From: Julie Hutton [REDACTED]
Sent: 20 June 2026 11:06
To: Botley West Solar Farm
Subject: Interested Party less than 250m from development boundary
Attachments: Cassington BWS.png; Eynsham road BWS.jpeg; View from garden.jpeg

I am writing to you as an Interested Party to follow up after PVDP's recent response to the Secretary of State's letter. My property is 135m from the development and located on the Eynsham road, Cassington.

Eynsham Road, Cassington Figure 2.1

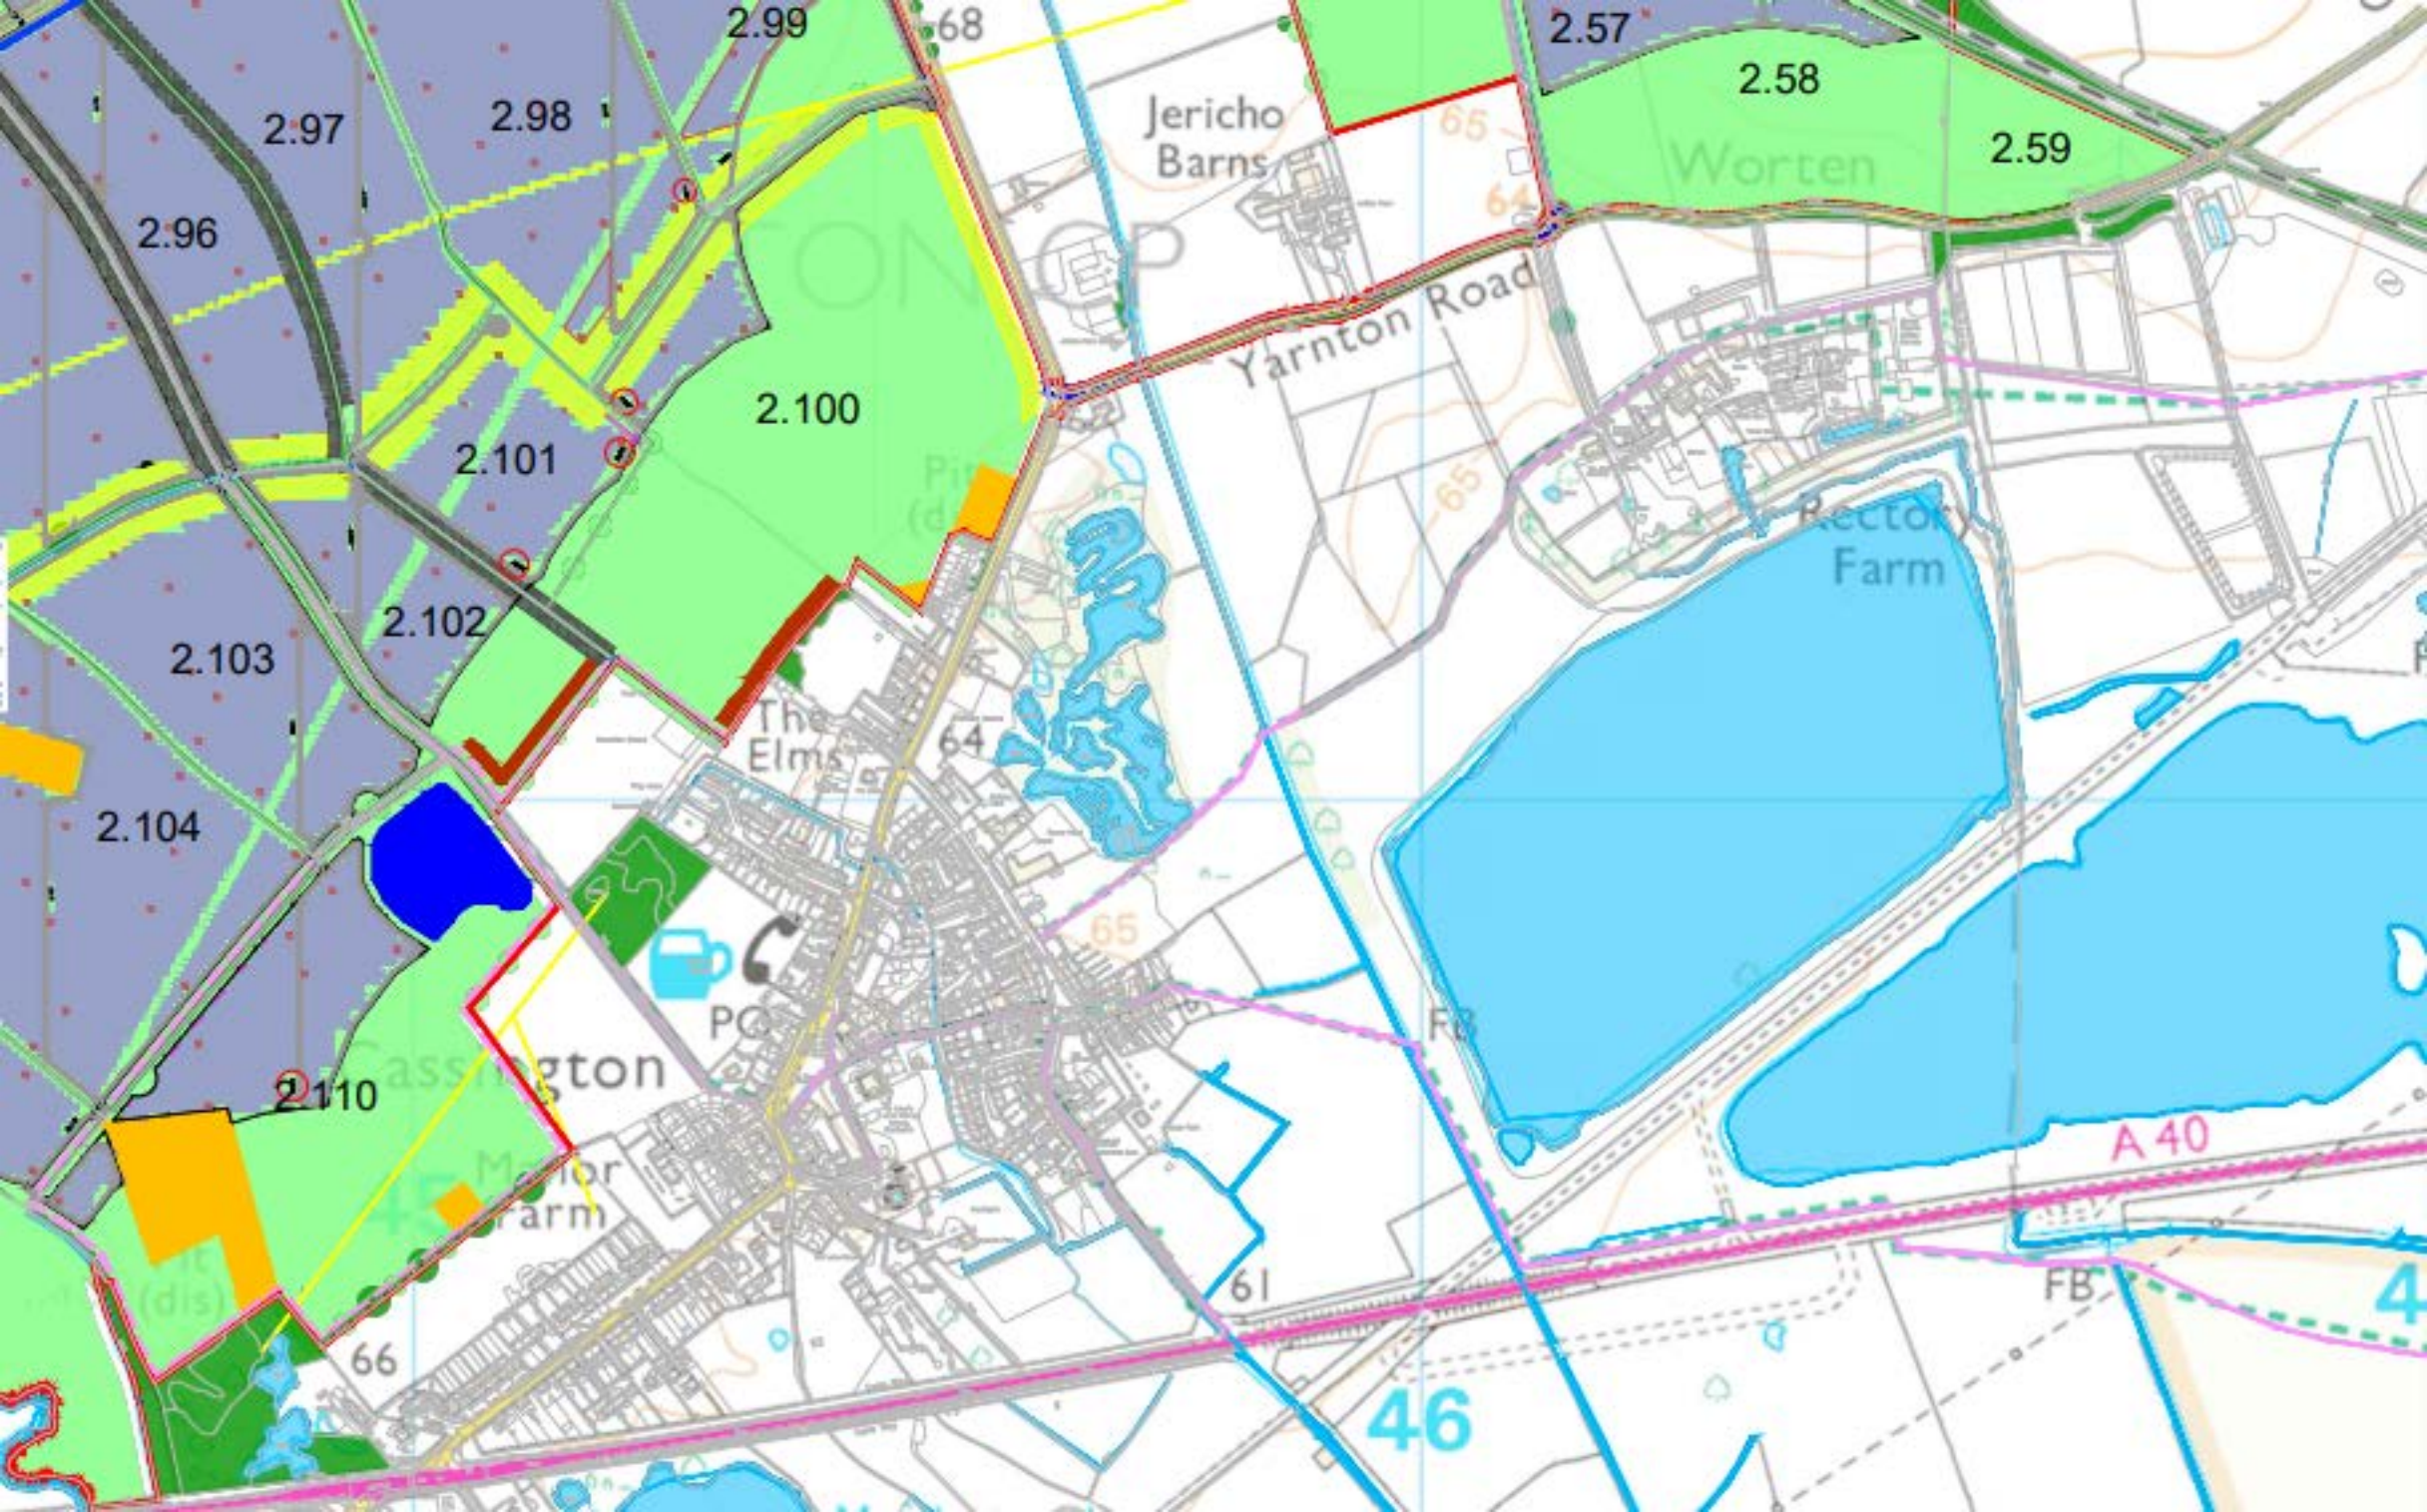
Many of the properties have NO vegetation or outbuildings restricting their views towards the proposed development. Those that do have sheds or greenhouses still have large areas of unrestricted views. A simple, direct request for this information, or better still a site visit, would have corrected these assumptions very readily and allowed the developer to offer an increased buffer and other mitigation at a point in the consultation where residents would've had the opportunity to respond. The "existing vegetation further to the north" does not exist in any meaningful sense - as is quite clear from my own photograph there is a sparse line of a few medium sized trees along the boundary of the buffer zone which do not obscure the view - this sentence provided by PVDP is misleading and appears to be an easy "catch all" to avoid further scrutiny.
